MONITORING YEAR 5 ANNUAL REPORT

GLADE CREEK II RESTORATION PROJECT

Alleghany County, NC
DEQ Contract 6843
DMS Project Number 92343
USACE Action ID 2009-00589

RE: Monitoring Year 5 (MY5) Report – Draft Submittal
Glade Creek II Mitigation Project
DMS Project # 92343
Contract Number 6843
New River Basin - CU# 05050001 - Alleghany County, North Carolina

Figure 2 Project Component/Asset Map
 Glade Creek II Restoration Project
 DMS Project No. 92343
 Monitoring Year 5 - 2020
 Allegheny County, NC

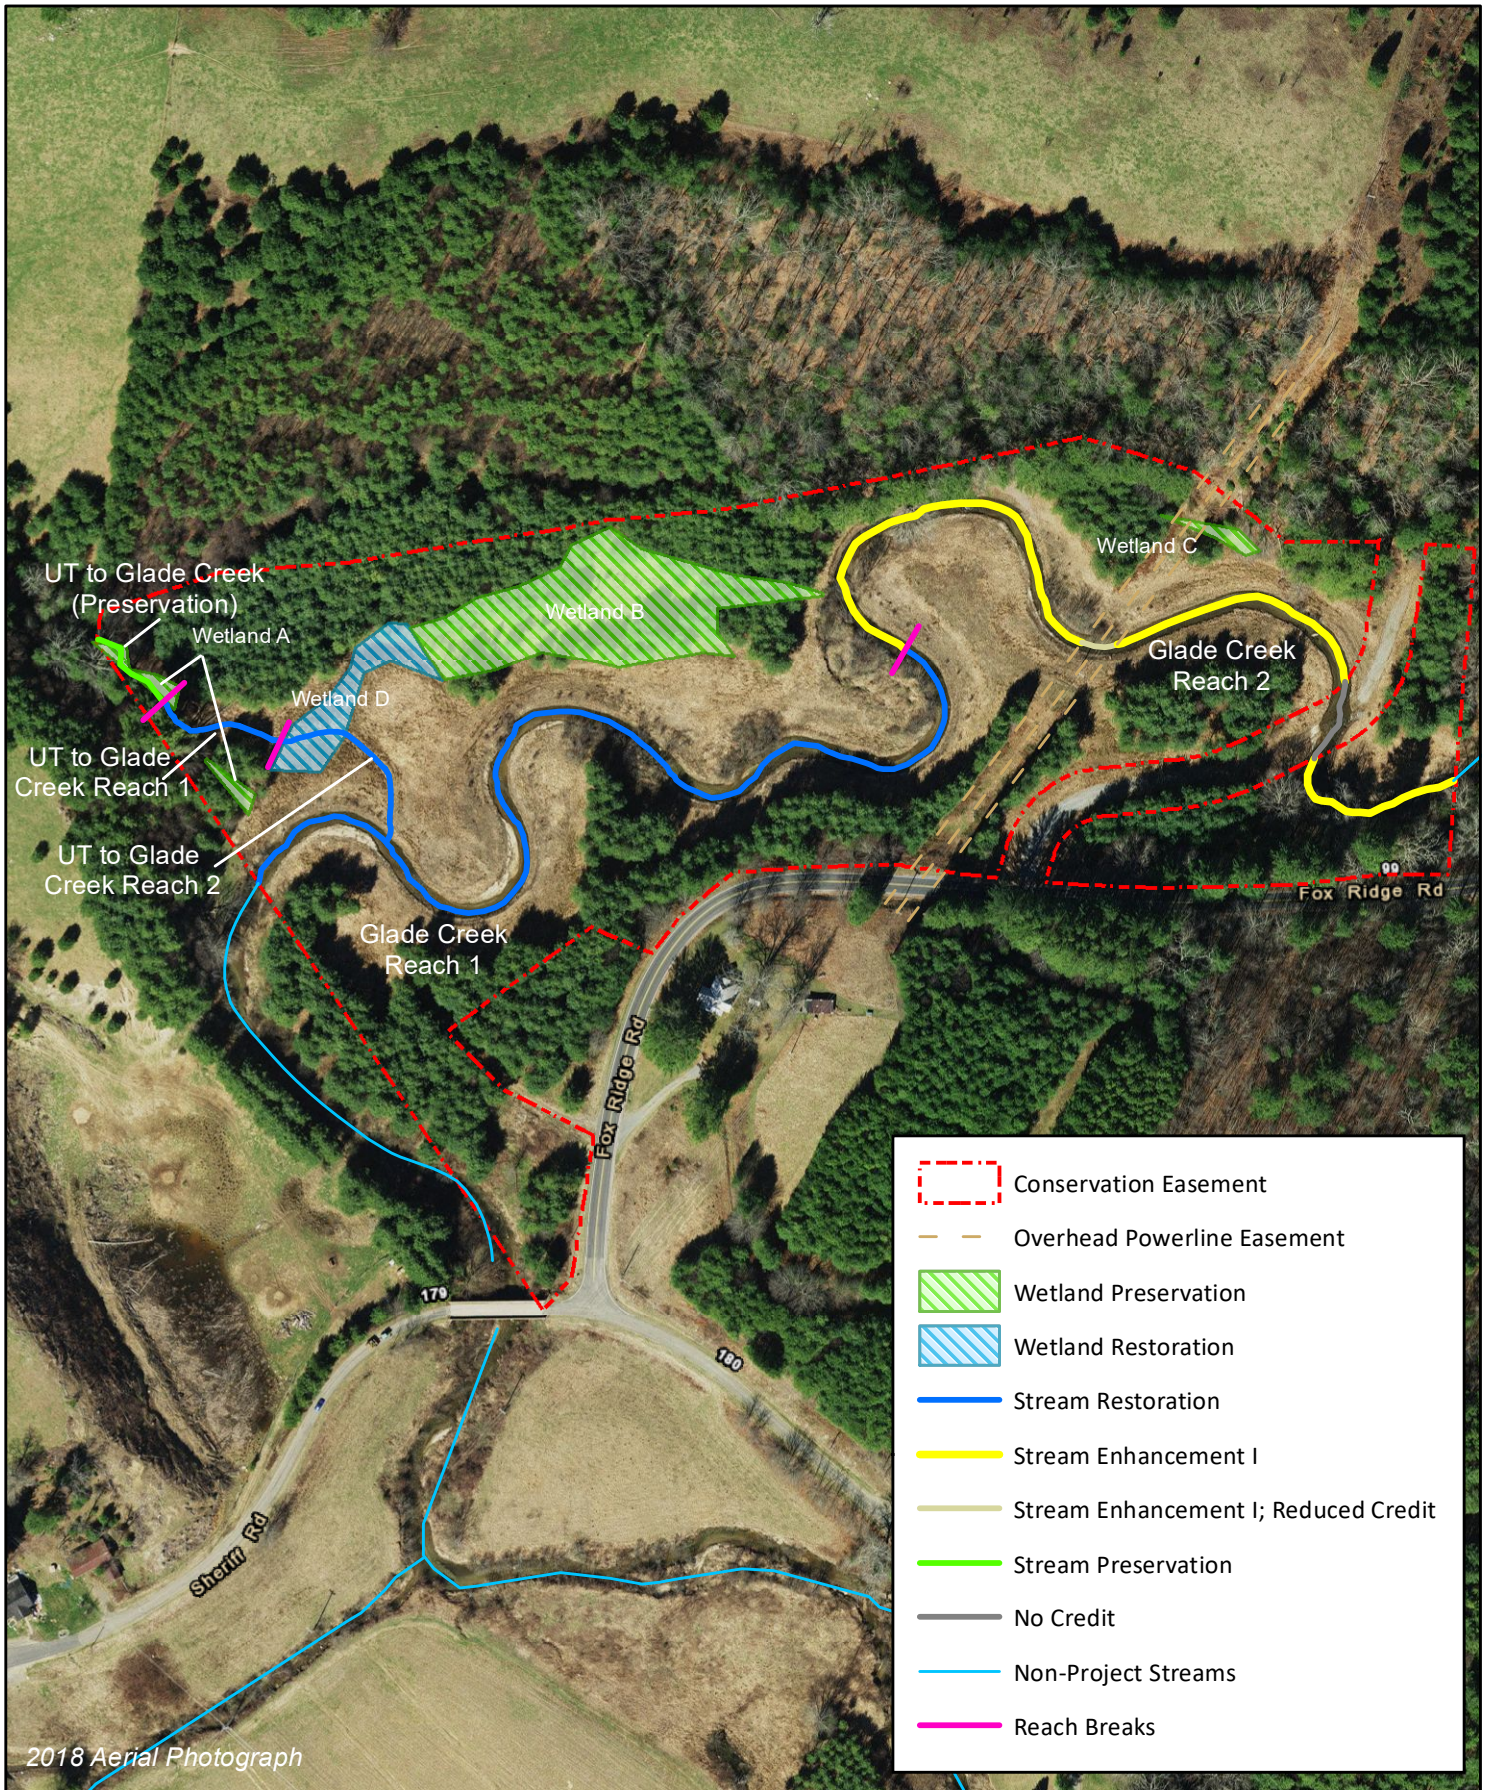
DMS comment: Figure 2 – Powerline and stream crossing cutouts are noted as “Reduced Credit” in the legend. If no credit is being generated by these segments they should be titled “No Credit”.

Wildlands response: As noted in Table 1, there is a 50% reduction in credit for the segment of Glade Creek under the overhead powerline easement. Further downstream, no credit is being generated for the segment of Glade Creek within the conservation easement break at the stream crossing. In Figures 2 and 3, the “No Credit” line color has been darkened to better differentiate with the “Reduced Credit” line color.
